Docket Number:	18-IRP-01
Project Title:	Integrated Resource Plan
TN #:	230484
Document Title:	Updated - Staff Paper - Review of Burbank Water and Power's 2019 Integrated Resource Plan
Description:	** This document supersedes TN# 229117 for accessibility purposes **
Filer:	Courtney Wagner
Organization:	California Energy Commission
Submitter Role:	Commission Staff
Submission Date:	11/1/2019 4:18:18 PM
Docketed Date:	11/1/2019

STAFF PAPER

Review of Burbank Water and Power's 2019 Integrated Resource Plan

Gavin Newsom, Governor
July 2019 | CEC-200-2019-009

Figure 1: Burbank and Energy Commission Energy Forecasts 2018-2030 (GWh)

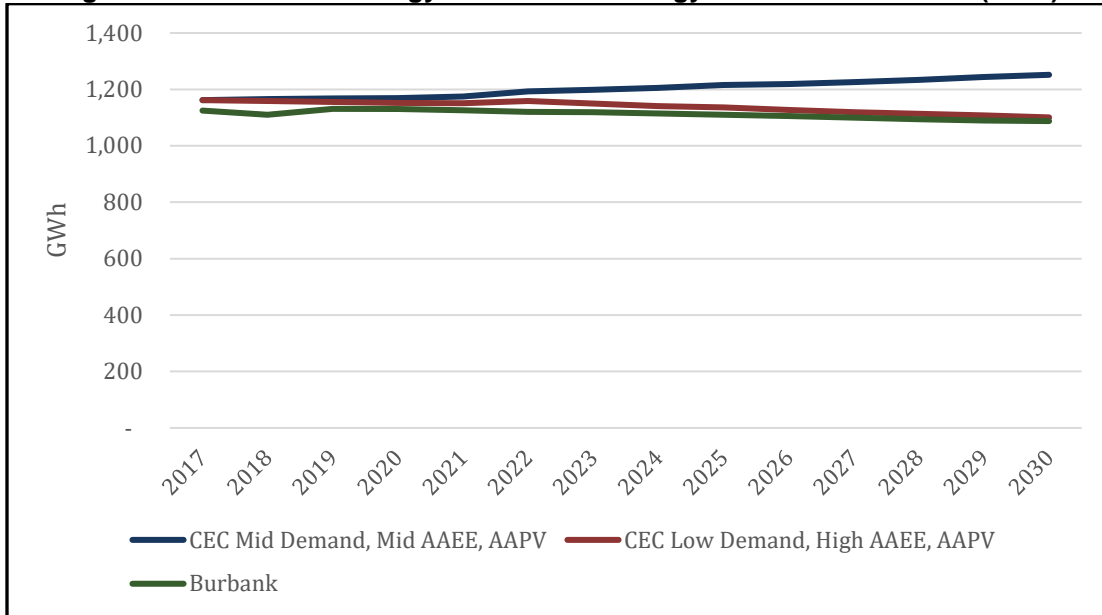
Figure 1 compares Burbank’s energy forecast with the Energy Commission’s forecasts, showing that Burbank’s energy forecast is lower than the Energy Commission’s mid demand forecast and almost identical to the low demand forecast.⁷ Burbank’s energy forecast shows a slight decrease in demand, with an average annual growth rate of roughly -0.3 percent from 2019 to 2030, compared to an increase in demand, with a growth rate of roughly 0.6 percent in the Energy Commission’s mid demand forecast. The difference between the Burbank and the Energy Commission mid demand forecast is 37 gigawatt-hour (GWh) in 2019, and grows to 164 GWh by 2030. The decrease in Burbank’s forecasted energy demand likely comes from its efforts to reduce annual energy and peak capacity needs through energy efficiency, distributed generation, time of use rates, and demand response programs. This also may explain why Burbank’s forecast is closer to the Energy Commission low demand forecast, which reflects higher levels of demand reduction.

Figure 2: Burbank and Energy Commission Peak Forecasts 2018 — 2030 (MW)

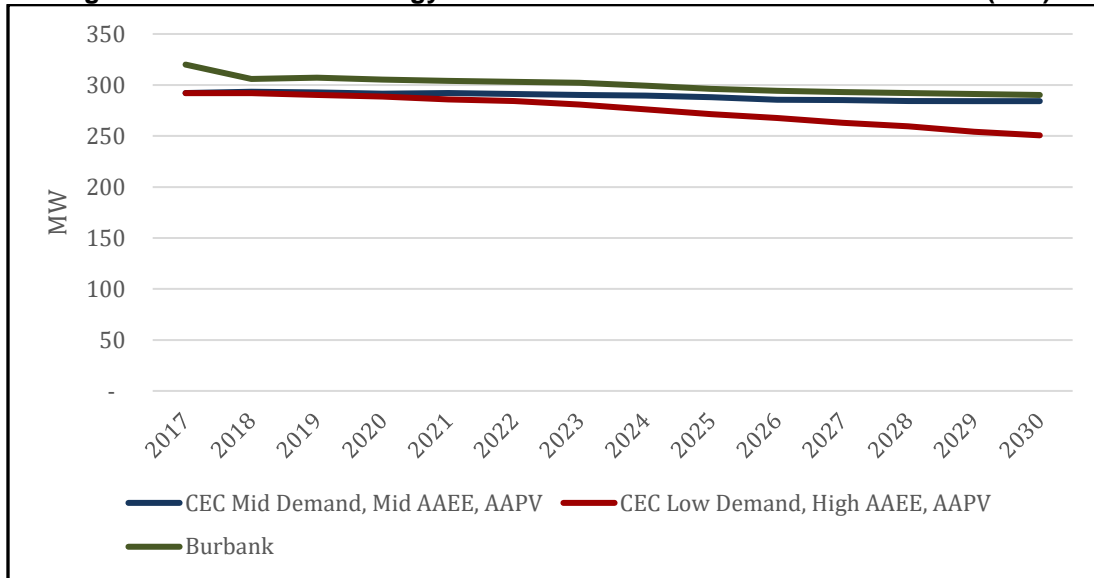
Burbank’s peak forecast is higher than the Energy Commission’s mid and low demand peak forecasts as shown in **Figure 2**. The peak forecasts show small annual average decreases, -0.46 percent for Burbank and -0.25 percent for the Energy Commission mid demand forecast. Burbank’s peak forecast is higher than the Energy Commission’s peak forecast in each year of the planning period. In 2019, the difference is 14 megawatt (MW) (5 percent), and by 2030, this difference decreases to 6 MW or (2 percent).

Figure 3: Sources of Renewables Portfolio Standard Eligible Energy (MWh)

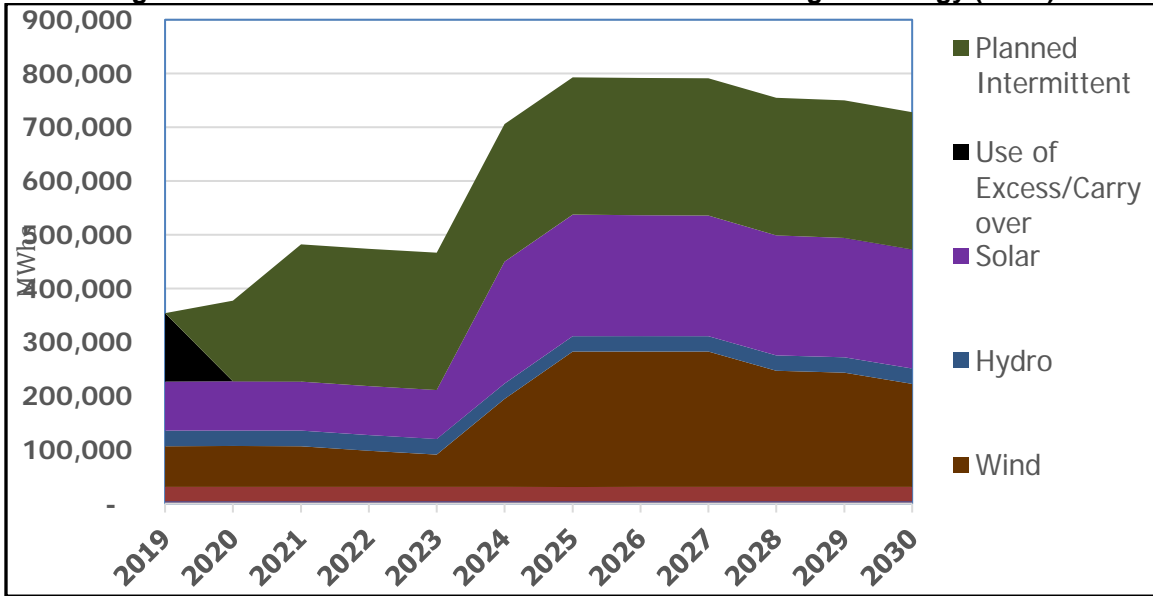
The utility expects to use its energy storage resources to help integrate increased amounts of renewable resources and address over-generation and ramping needs from solar. **Figure 3** and **Figure 4** show the increase in renewable generation from 2019 to 2030. Burbank expects to reach the following RPS levels over the planning period:
